<b>Docket Number:</b>	14-AAER-02
<b>Project Title:</b>	Computer, Computer Monitors, and Electronic Displays
<b>TN #:</b>	204778
<b>Document Title:</b>	Comments from Natural Resources Defense Council on CEC Computer and Displays Staff Report
<b>Description:</b>	N/A
<b>Filer:</b>	System
<b>Organization:</b>	Natural Resources Defense Council/Pierre Delforge
<b>Submitter Role:</b>	Public
<b>Submission Date:</b>	5/29/2015 3:21:43 PM
<b>Docketed Date:</b>	5/29/2015

## **NRDC Comments on CEC Staff Analysis of Computers, Computer Monitors, and Signage Displays**

**2015 Appliance Efficiency Pre-Rulemaking  
Docket Number 14-AAER-2**

**Figure 1 – Efficiency Profiles of 80-PLUS GOLD Power Supplies**

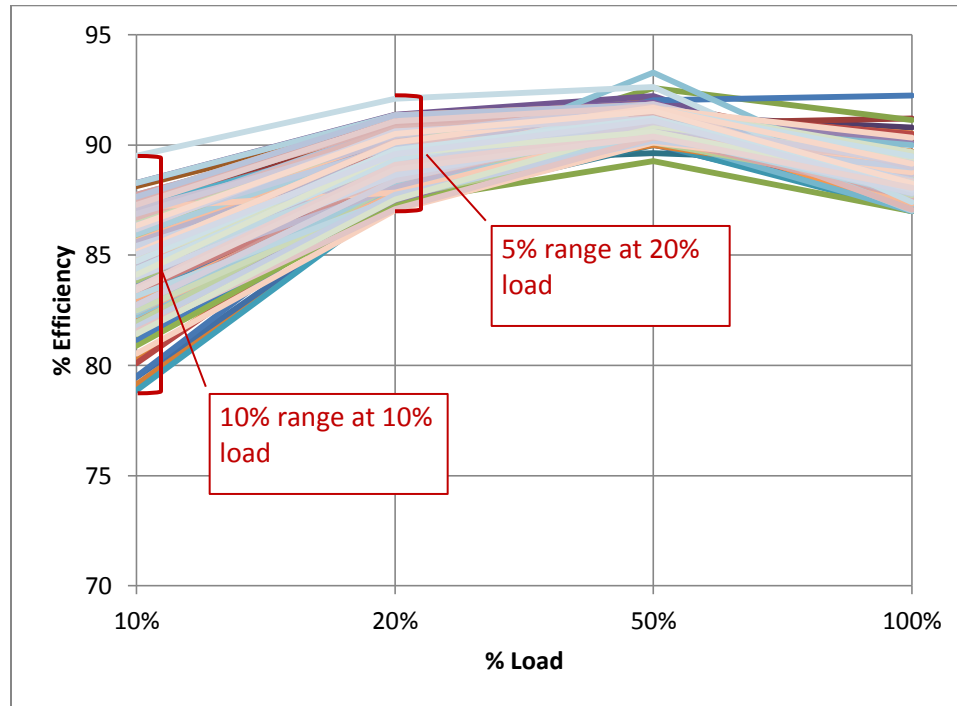
The 80-PLUS program has been testing all power supplies at the 10 percent load point since January 2012, despite this load point not being part of the 80-PLUS standard. The test data is available on the 80-PLUS website . An analysis of this data, as shown on Figure 1, indicates that the range of efficiencies is twice as large at 10 percent than at 20 percent load, confirming that the 10 percent load range is not consistently optimized.

We recommend the CEC adopts efficiency requirements of 84 percent and 0.8 power factor at 10 percent load, in alignment with ENERGY STAR v6's power supply efficiency incentive allowance.
